MASTER DRAINAGE PLAN  
ELDORADO PARK SUBDIVISION

REVISED DRAINAGE REPORT  
FOR UNIT 1

Drainage File L9/D7  
DRB No. 97-13

**Re: Eldorado Park Subdivision, Unit 3 & 4 Grading and Drainage Plan**  
**Engineer's Stamp not dated, (L9/D7)**

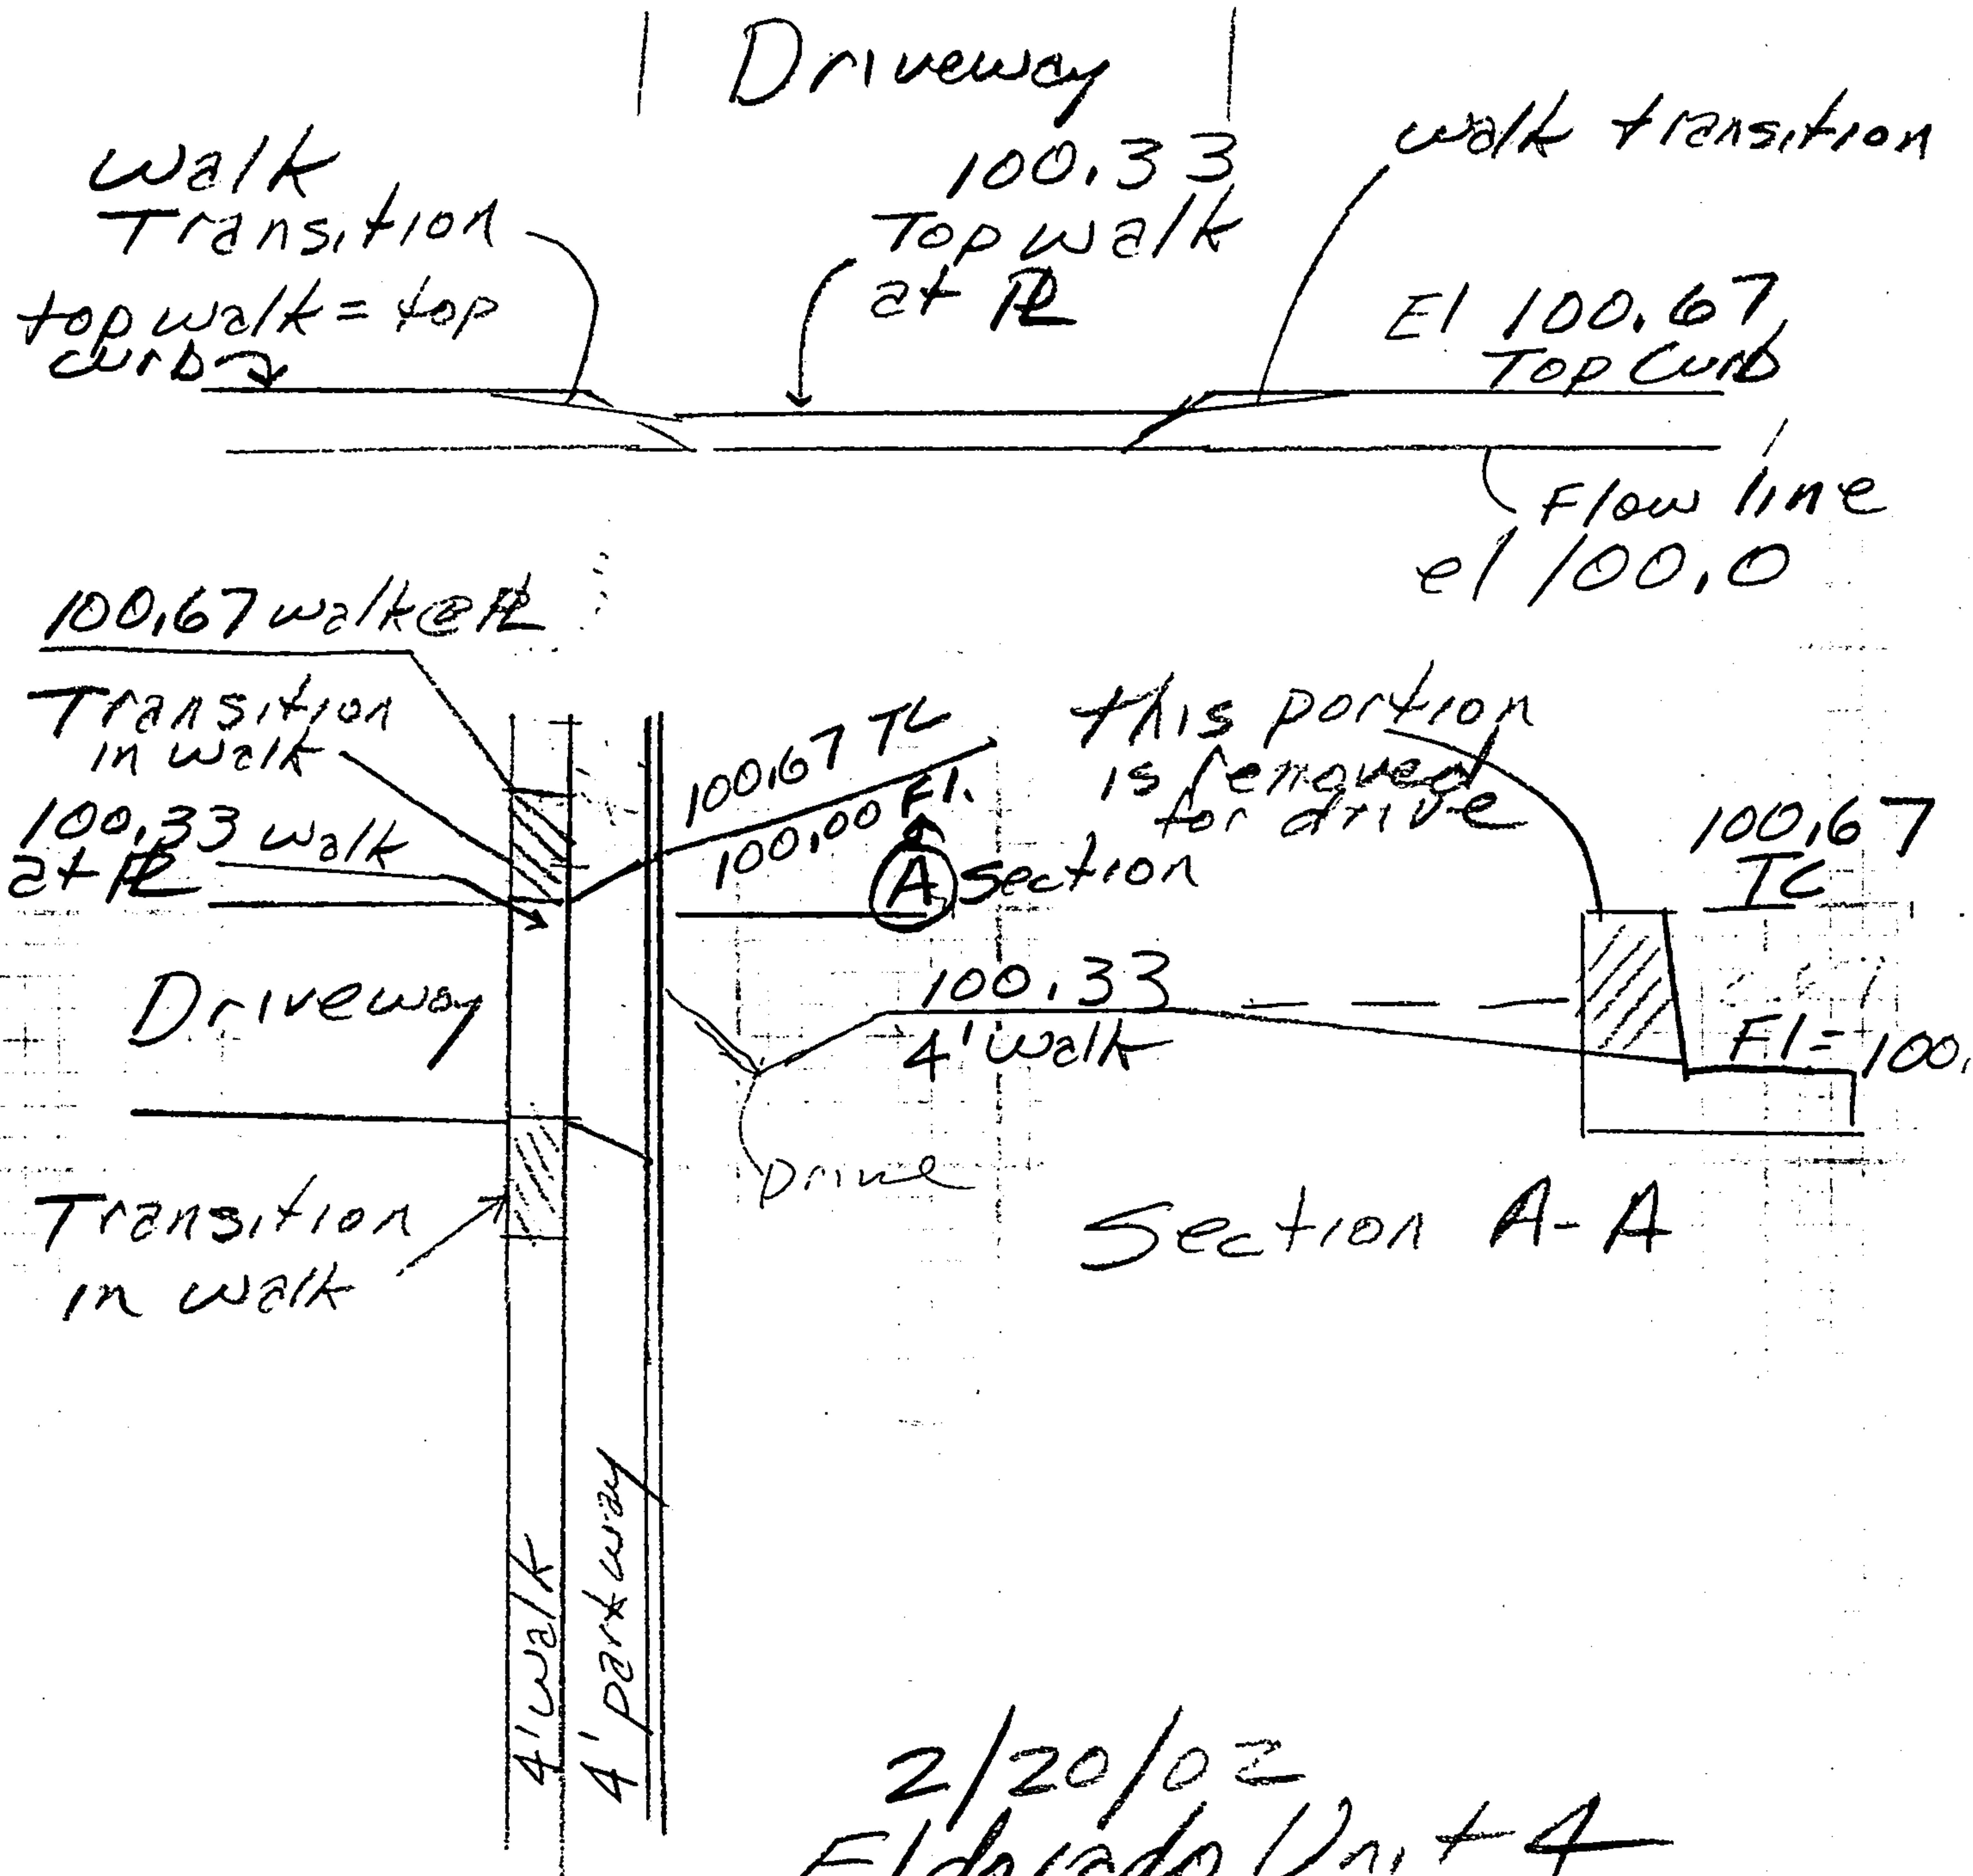
- The Work Order plans from Unit 2 show a 48" RCP in 94<sup>th</sup> but your report states that a 36" RCP is in 94<sup>th</sup> St. Please clarify this.

- You mention that you are adjusting the rainfall amount to Zone 1 and increasing the density. Does this make the runoff increase or decrease from the original report? If it increases, you will need to verify capacity downstream.

- Tower Rd is a minor arterial. Draining backyards across the sidewalk and into the roadway is not prudent for a facility of that designation. Please provide agreement that allows for this (as stated on the grading plan).

- On the Units 3&4 plans, please show the existing pad elevations from Units 1& 2 and any slope or wall needed to fit with these lots. All side yard retaining walls must be CMU or equal (not railroad ties). There appears to be a 4' bust at the return. Please add elevations from the SAD (at 100' intervals) for Tower and 98<sup>th</sup> on these grading plans.

- Please add spot elevations at all four corners (and extensions to the R/W) of each lot and applicable slope or retaining wall symbols to the unit-specific grading plans.

- Please add a date to the report and grading plans.

- By diverting the arroyo as proposed, the remaining three lots from Unit 2 can be developed. It would be prudent to include these in your plan as well. Please show actual grading of the arroyo and how it will fit in with the ultimate grades of the subdivision.
- Sheets 1 of 3 and 2 of 3 were difficult to read. Please resubmit these readable.

- The RCP in 94<sup>th</sup> has been corrected to be 48" in diameter.
- The net result of adjusting the rainfall to Zone 1 (reducing rainfall) and increasing the density to more closely represent the planned land use was a slight reduction in the 100-year flow values. The most significant of which was runoff from Dean Drive. The flows from Dean, south of Rowen, decreased from 26 cfs in the 100-year storm to 23 cfs.

- Weems has been lowered as much as practical and yet, there are a few places where the back yards have to drain to Tower. This had been agreed to in a meeting with Fred Aguirre and Elvidio Diniz, while Mr. Aguirre was still the head of hydrology at the City. Mr. Diniz was under the impression that you had been aware of this. Mr. Aguirre and Mr. Diniz had agreed that this is the most practical alternative. As you'll see on the plans, back-yard drainage to Tower Road has been kept to a minimum.

- We have provided spot elevations and the cross section detail of the pads, side to side, as you had requested. All slopes between lots are 3H to 1V or flatter. It is typical of the side lot slopes to start at 3:1 at the back of the lot and end up close to the slope of the street at the front. We say these slopes vary, maximum of 3:1.

- I have re-stamped these plans and put the date on them. Thanks!
- The grading for the last 2 lots in Unit 2 are now shown. As we discussed, no new retaining walls are needed there.

- I am sorry the reference plans from Units 1 & 2 were difficult to read. Blue lines were all that I had inherited. We are supplying black-line prints of those approved drawings (from the Units 1 & 2 drainage report) for sheets 1 and 2 of 3. You mentioned that sheet 3 was ok (because the lettering is so large).

You will notice that the grades have changed in the central part of the plans. And we have incorporated ideas from the DRC meeting, by tightening the knuckles. A hammerhead configuration at Dean and Weems would not work.
